ZON2011-00040 & 21-2011-4.04

Baker Creek PUD Amendment - NE 46th Street & Hubbell Avenue ZON2011-00040

**BAKER CREEK  
SENIOR LIVING**  
DES MOINES, IOWA

① FRONT ELEVATION

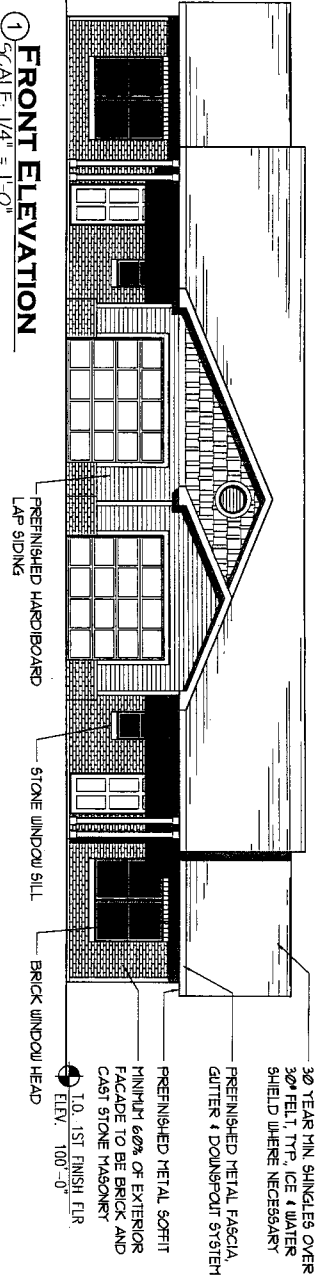
19. The building elevation for the multiple-family residential building shall be modified to eliminate the recessed area in the roof above one of the entrances.

## DEVELOPMENT PLAN W/O TOPO

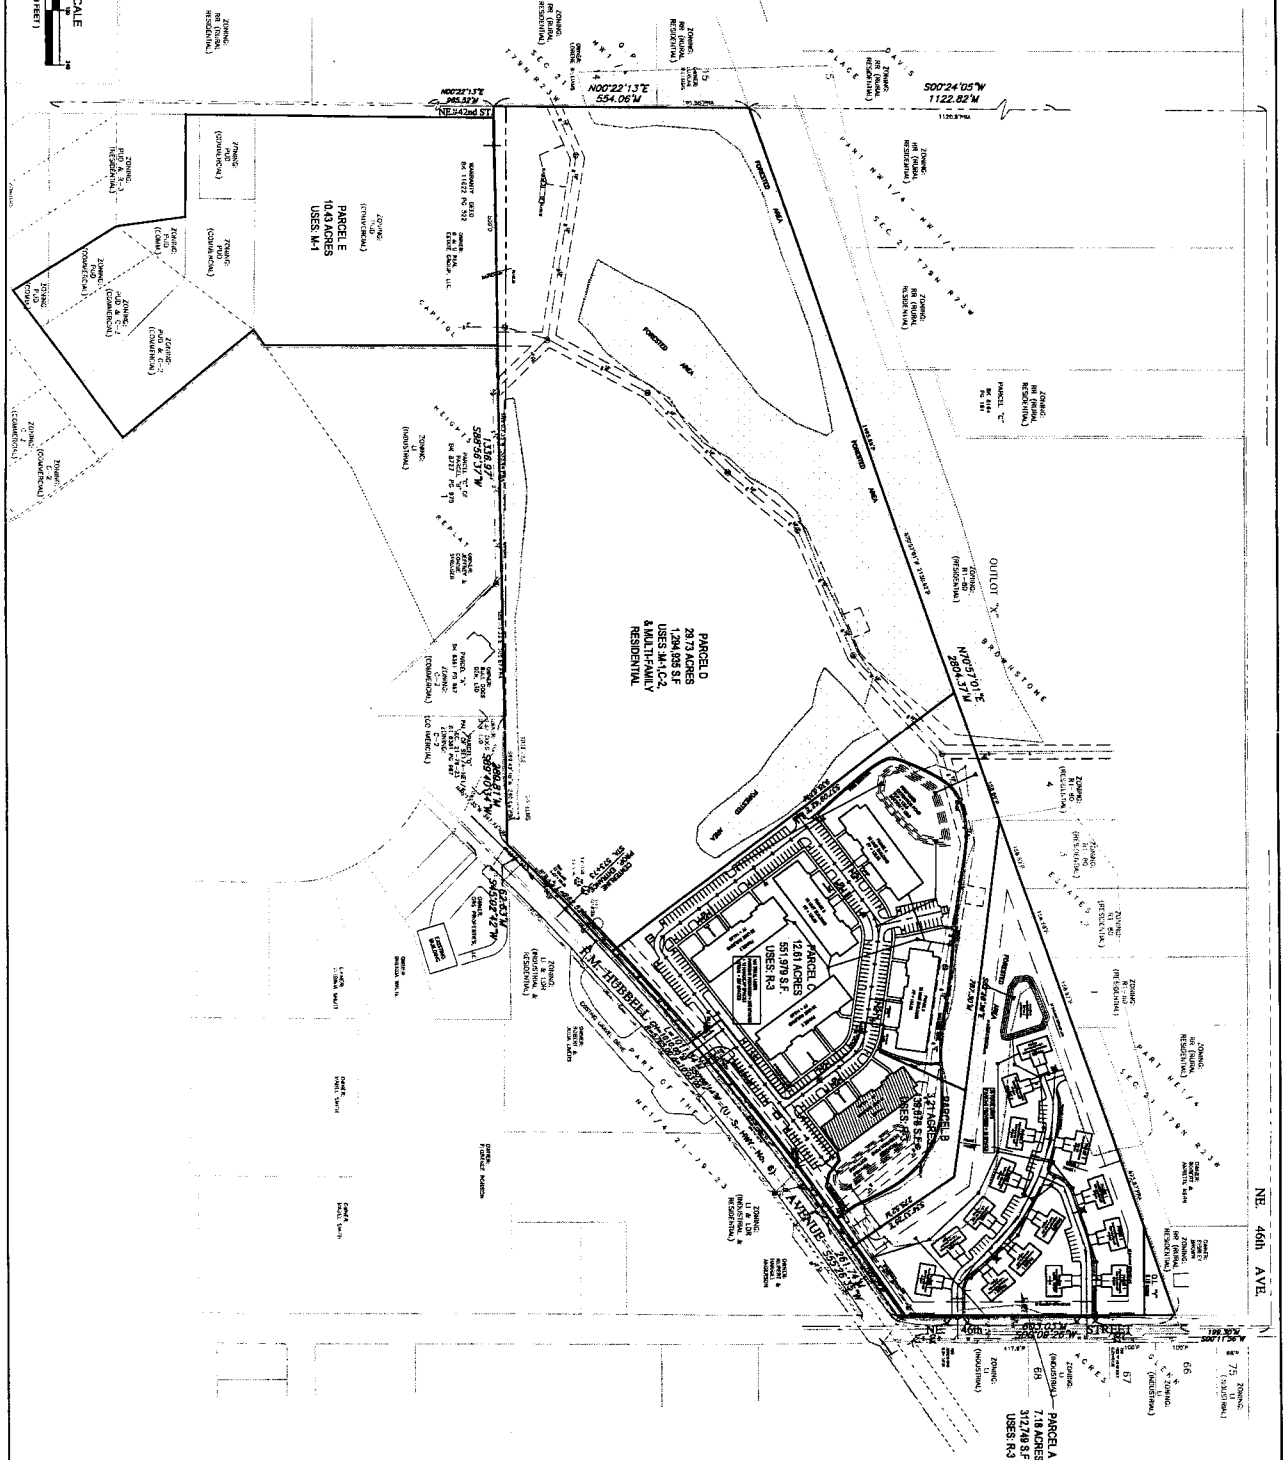
9. A note shall be added to state that prior to any construction, the developer shall confirm that the driveway approach shown is at the approved access location on Hubbell Avenue.

11. A note shall be added to state that the portion of the off-street parking area on Parcel C that is between the drive approaches to Hubbell Avenue shall be reconfigured to accommodate a driveway adequate for industrial traffic at any time that Parcel D is developed for an industrial use.

13. The Conceptual Plan shall identify dimensions of the driveway approach width and radius. The radius should be 10'-20'.
14. The Conceptual Plan shall demonstrate sidewalks along all street frontages and provide adequate pedestrian connections to the network of sidewalks within the complex.
